Application Note AN-1103

IRS2103 and IR2103 Comparison

Figure 9A. Turn-On Rise Time vs Temperature	**Figure 6A. Turn-On Rise Time vs. Temperature**

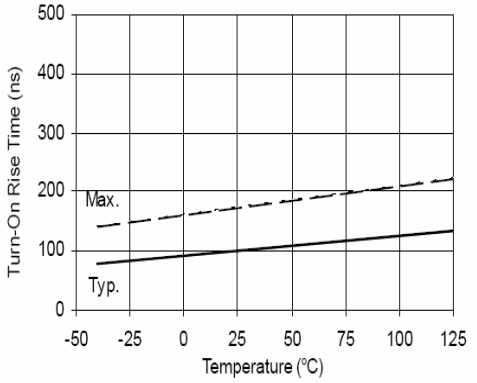
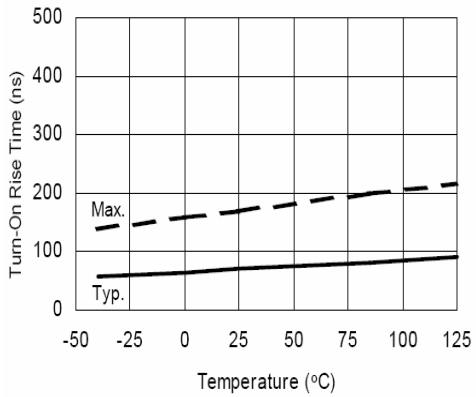
The IRS2103 has faster rise and fall times when compared to the IRS2103.

Figure12A. Logic "1" ($\overline{HIN}$) & Logic "0" ($\overline{LIN}$) Input Voltage vs Temperature

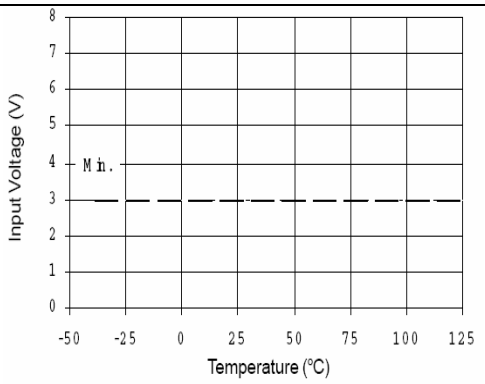
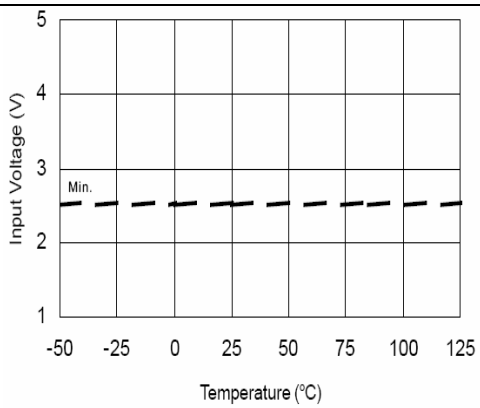
1. V_{IH} has been reduced to 2.5 V for better 3.3 V logic compatibility.
2. The V_{OH} and V_{OL} are tested using a new standardized test condition of Io=2 mA. The output driver's on resistance is lower for IRS2103, which improves immunity against the Miller effect.
3. The typical values for I_{O+} and I_{O-} are increased, which allows faster switching.
